DEVELOPMENT APPLICATION ASSESSMENT REPORT

Application Number:	DA2020/0034
----------------------------	-------------

Responsible Officer:	Jordan Davies
Land to be developed (Address):	Lot B DP 359788, 11 Moore Street CLONTARF NSW 2093
Proposed Development:	Alterations and additions to a dwelling house
Zoning:	Manly LEP2013 - Land zoned R2 Low Density Residential
Development Permissible:	Yes
Existing Use Rights:	No
Consent Authority:	Northern Beaches Council
Land and Environment Court Action:	No
Owner:	Belinda Gaye Anderson
Applicant:	Belinda Gaye Anderson

Figure 1 - Diagram showing level of ground floor living room window relative to the proposed development.

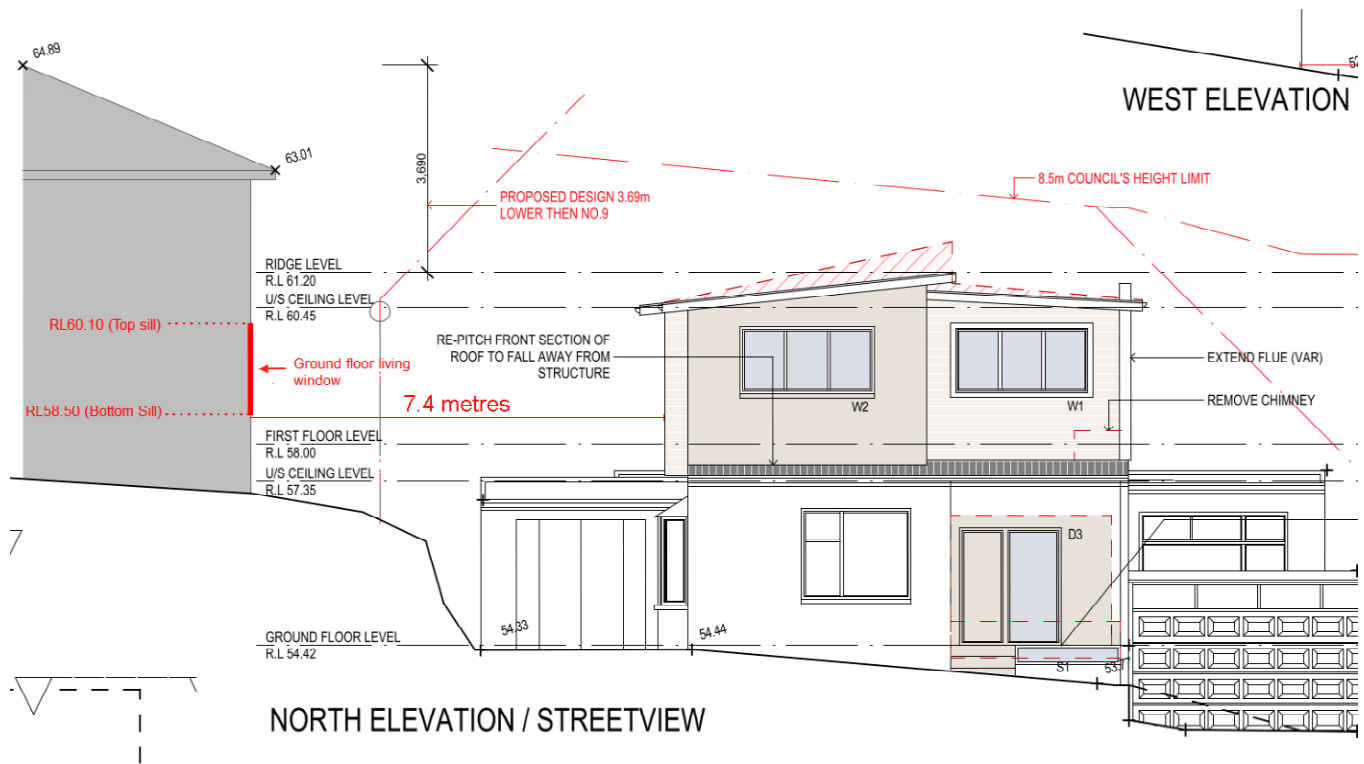
The proposal will result in additional overshadowing of the rear yard of 9 Moore Street on 21 June (winter solstice) during the afternoon period. However, this is not unreasonable given the north/south orientation of the site. The dwelling on 9 Moore Street has an upper floor terrace directly adjoining the living room/kitchen, which will continue to receive solar access without any impact from the proposed development, therefore complying with the control. The upper floor living room window and kitchen window will retain the current amount of solar access as they are located above the gutter line of the proposed development, complying with the control.

The ground floor living room window will still receive the required amount of solar access with sill heights at a level that will not be impacted by the proposal taking into account the level difference and setbacks between the two dwellings (as depicted in Figure 1)

Shadow diagrams have been provided demonstrating the overshadowing impact on 21 June (winter solstice), as required by the DCP. There is no requirement for the applicant to provide summer shadow diagrams given solar access improves either side of 21 June.
